IREDELL COUNTY HEALTH DEPARTMENT

IMPROVEMENT PERMIT / AUTHORIZATION TO CONSTRUCT / OPERATION PERMIT / EXISTING SYSTEM

✓ SUBDIVISION: THE POINT ON NORMAN SECTION: 1A LOT # 69 LOT AREA: 1.112 AC DESIGN FLOW: 480 L.T.A.R.: .275

Lot 69, The Point

AS BUILT SKETCH

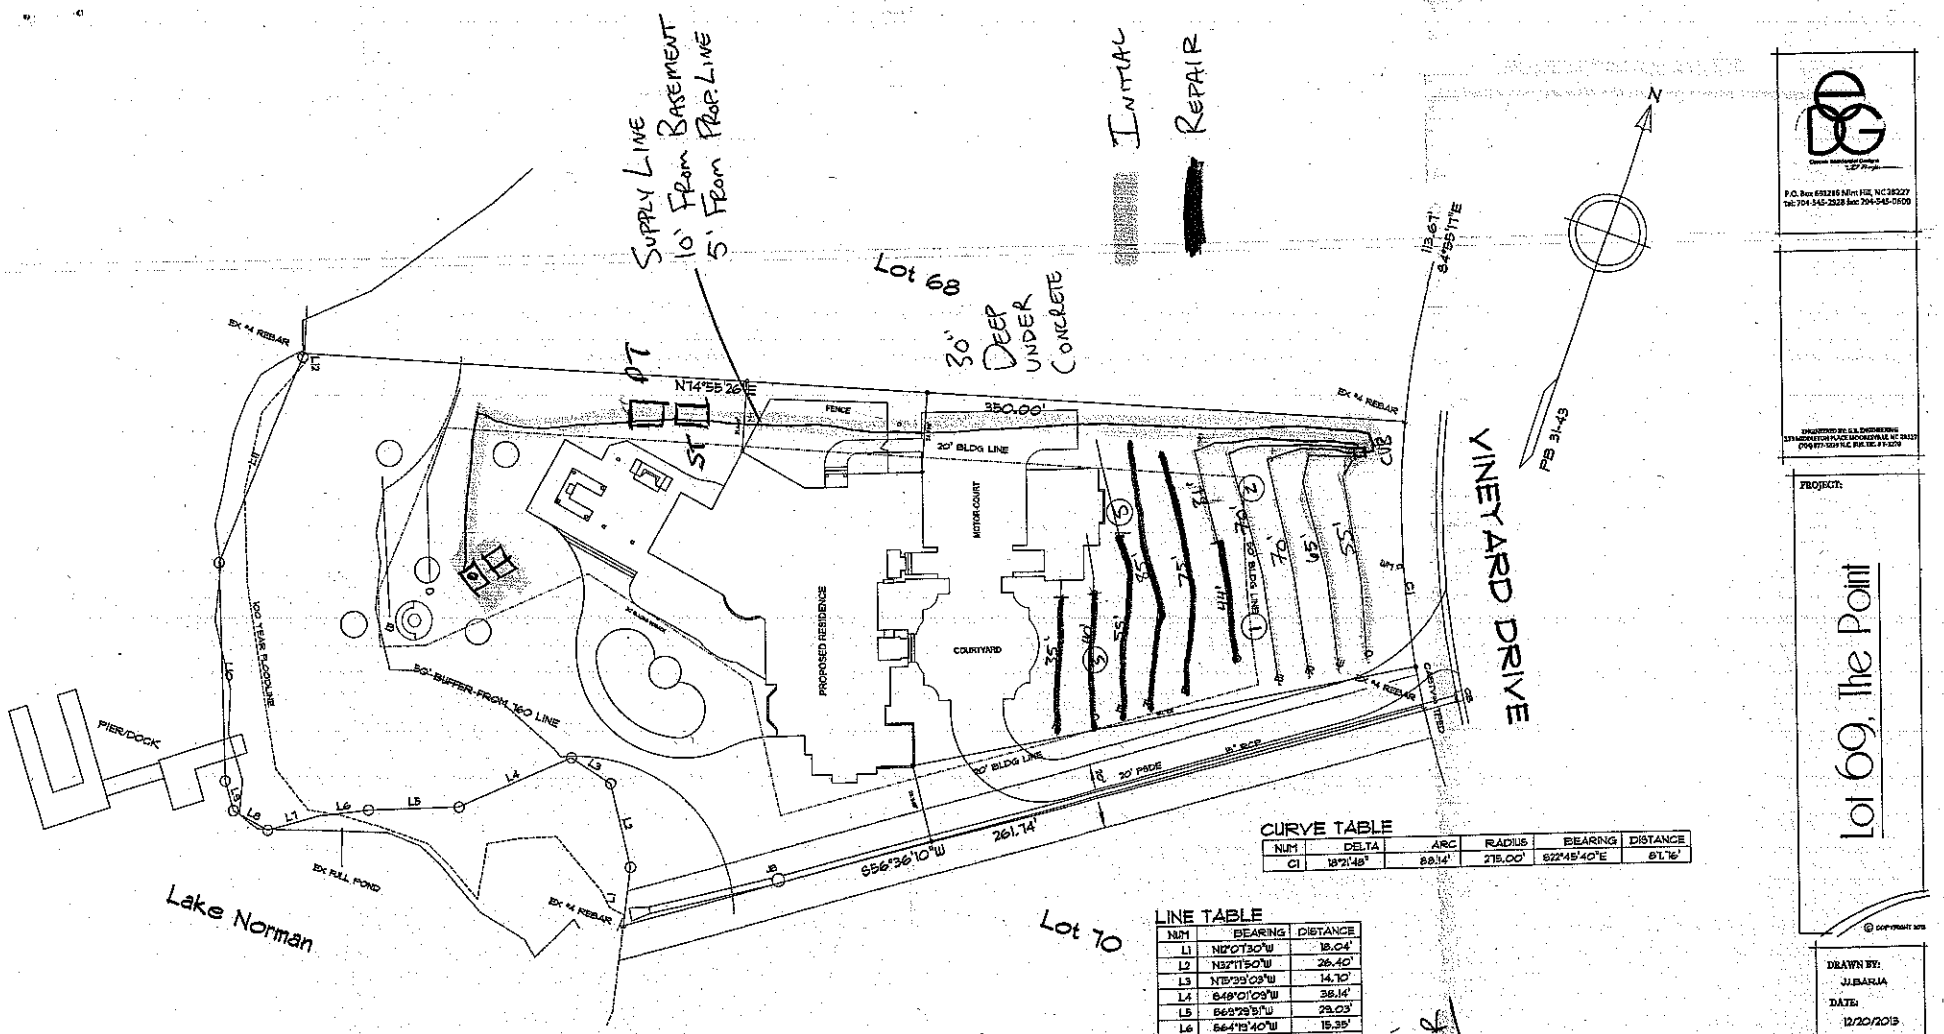
3/1/16 Checked tanks. Tanks moved to side of house, meets all setbacks
3/7/16 Checked lines, installed essentially as drawn.

5/19/16 Set pressure, checked leak & alarm

Location of the proposed Inground pool addition does not appear to impact the existing on-site septic system or well. **NOTE: Must keep pool cut at least 15ft to Septic
